Viking CCS Pipeline

9.41 Design Changes 5 to 8: Environmental Technical Note

Document Reference: EN070008/EXAM/9.41

Applicant: Chrysaor Production (U.K.) Limited,
a Harbour Energy Company
PINS Reference: EN070008
Planning Act 2008 (as amended)
The Infrastructure Planning (Applications: Prescribed Forms
and Procedure) Regulations 2009 - Regulation 5(2)(q)
Date: June 2024

FIGURE TITLE
Figure 5 (1 of 3)
Updated Order Limits / DCO Site Boundary

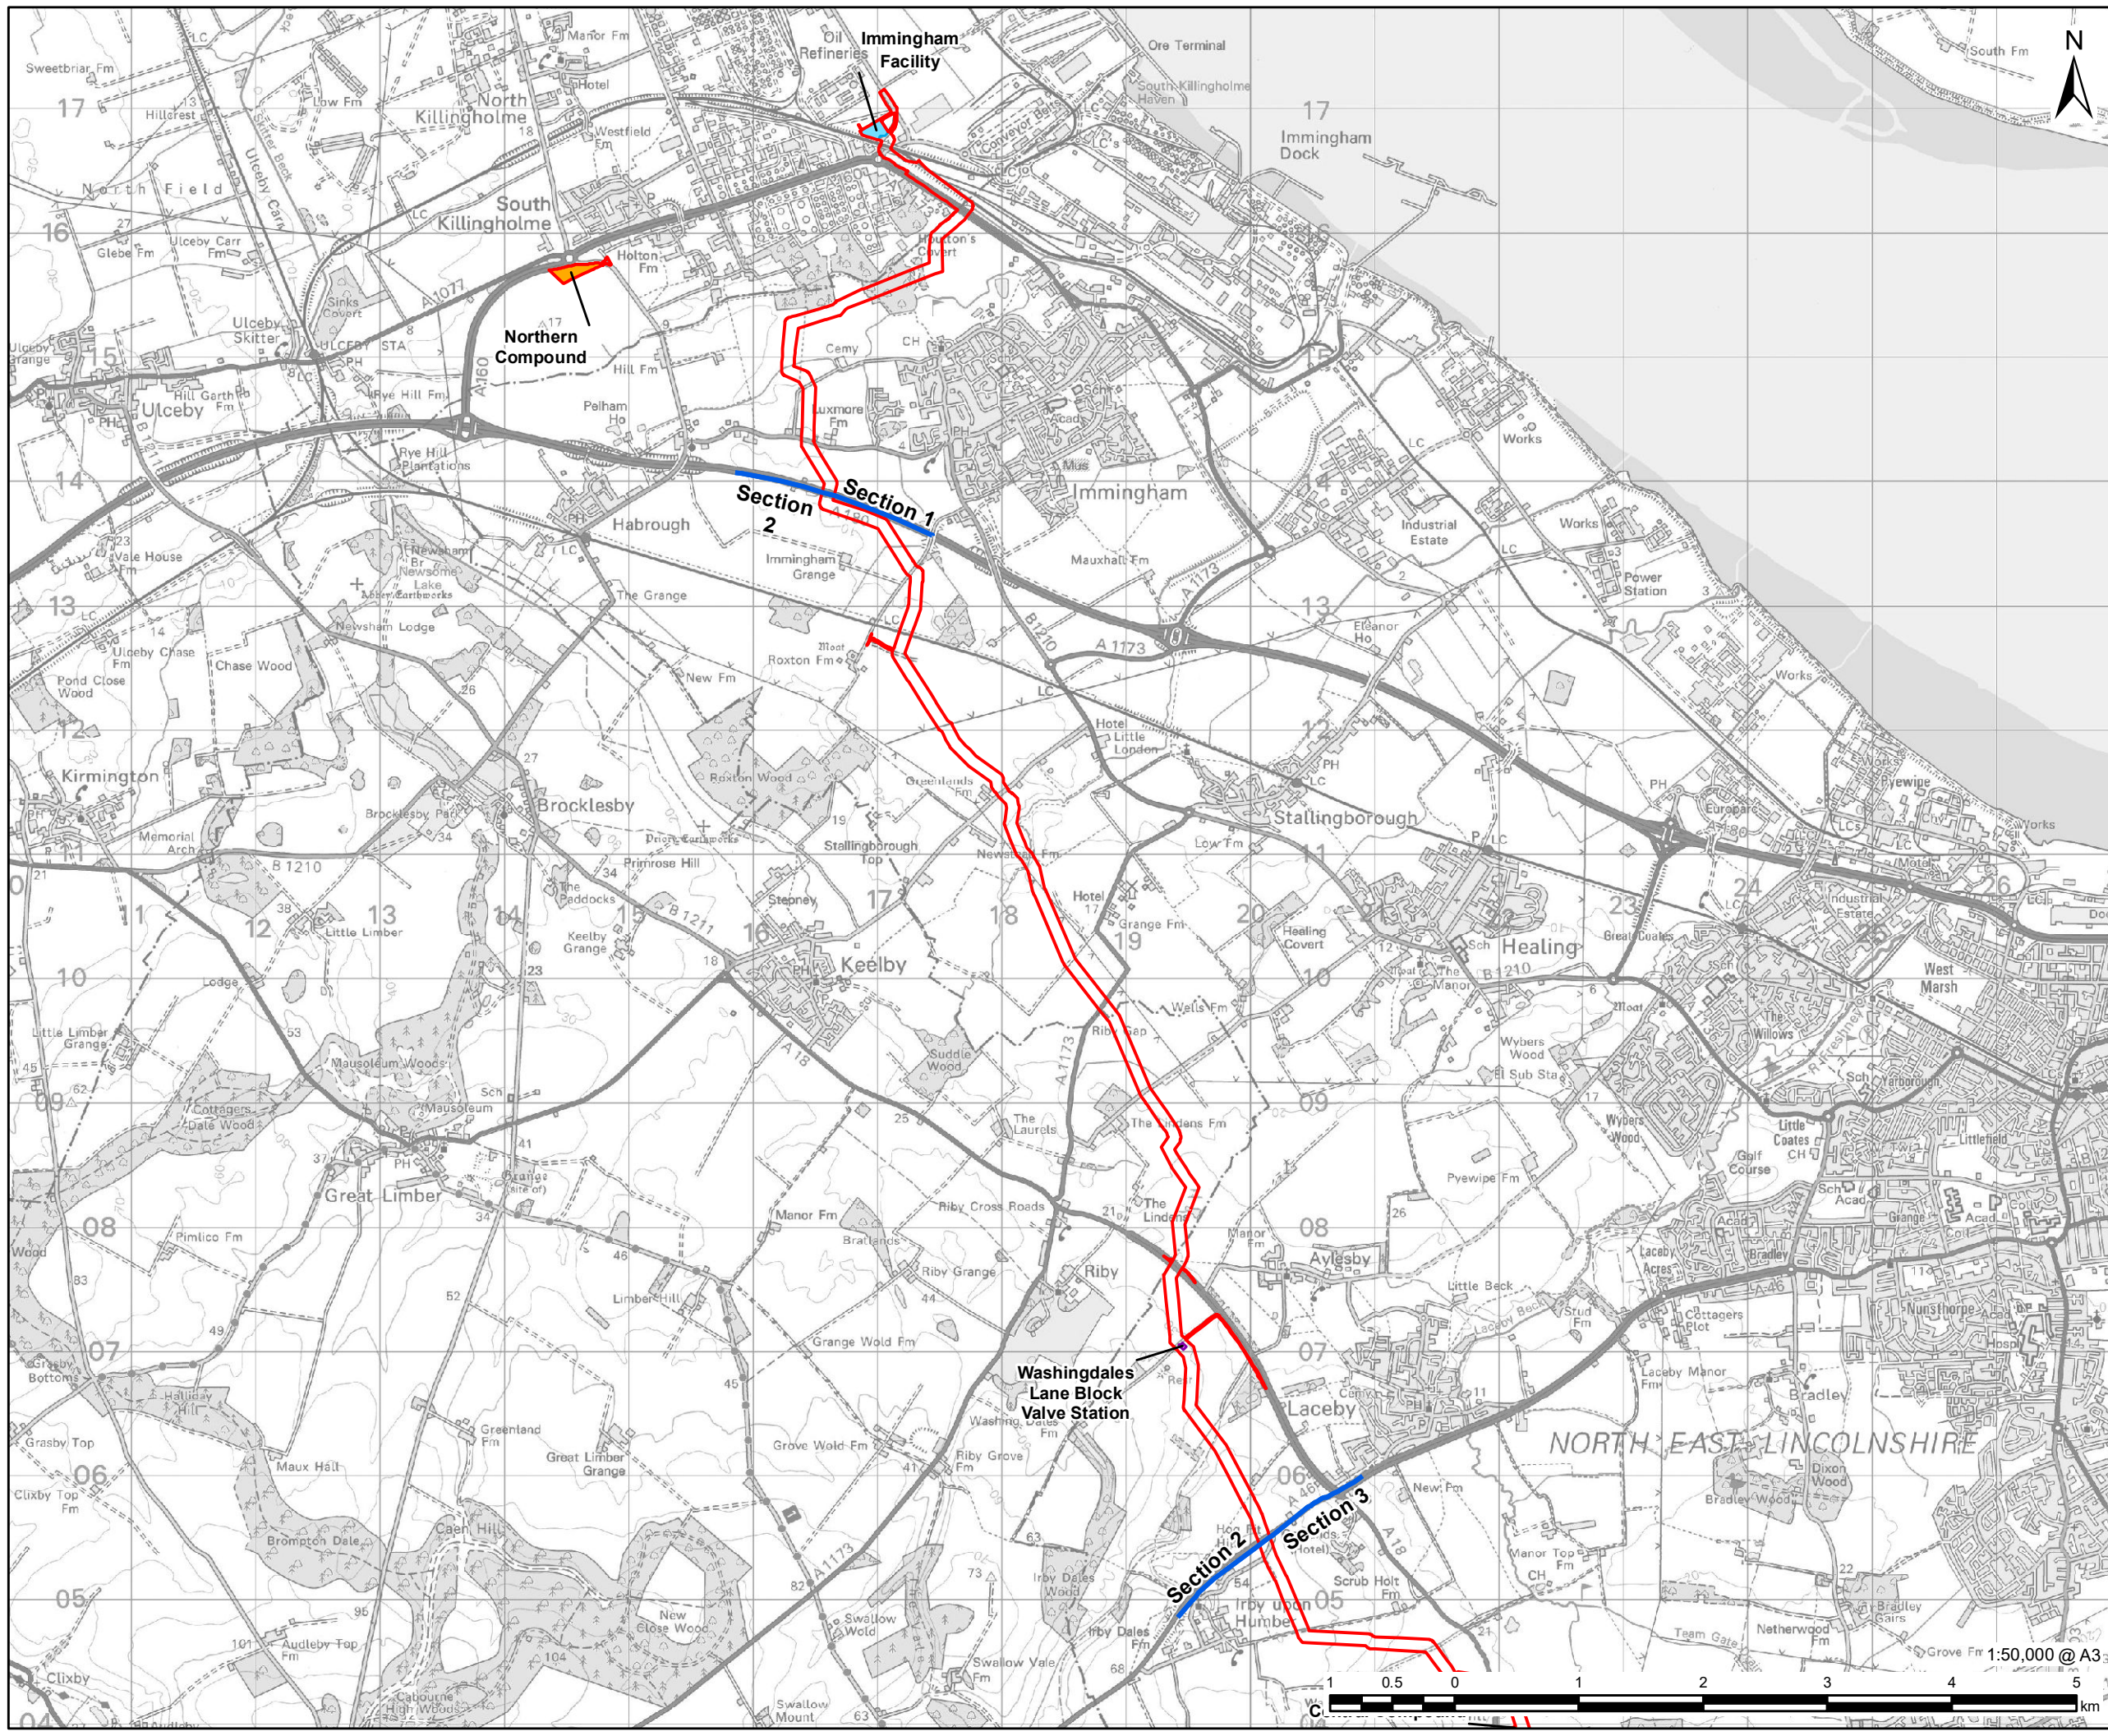
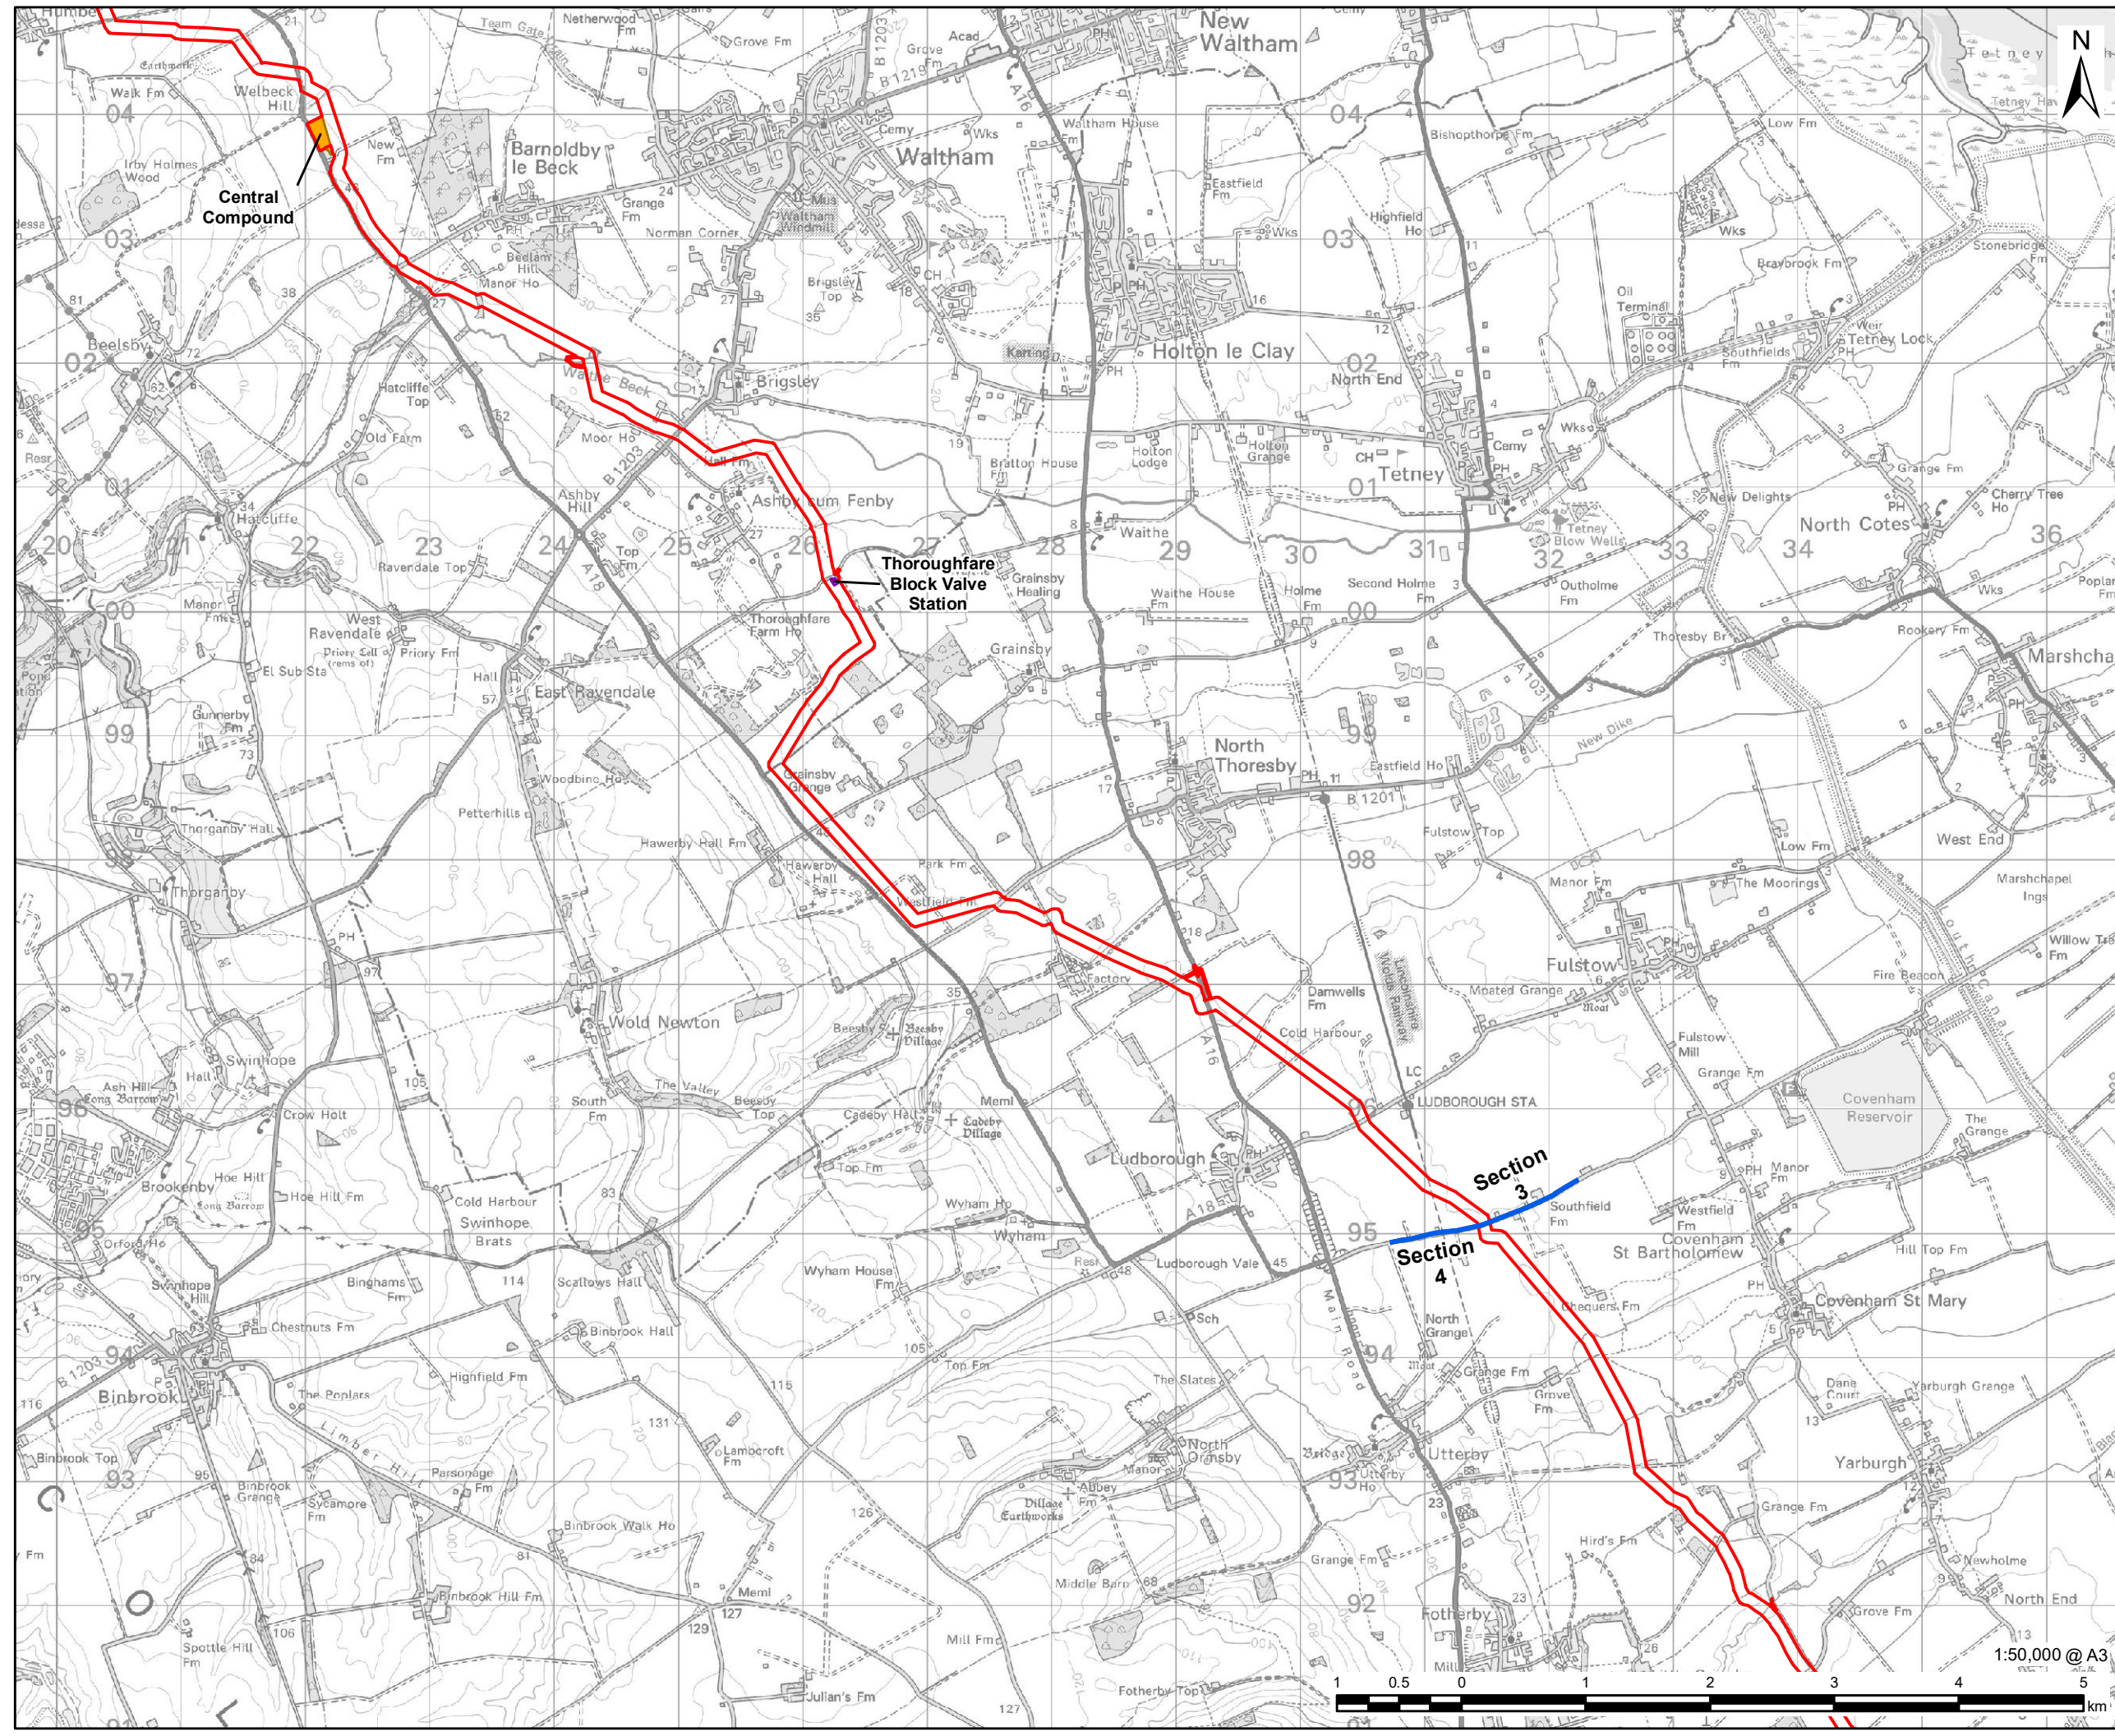
2.6.1 **Figure 5** presents the updated Order Limits/DCO Site Boundary for the proposed Development, taking into account the proposed design changes 3 to 8.
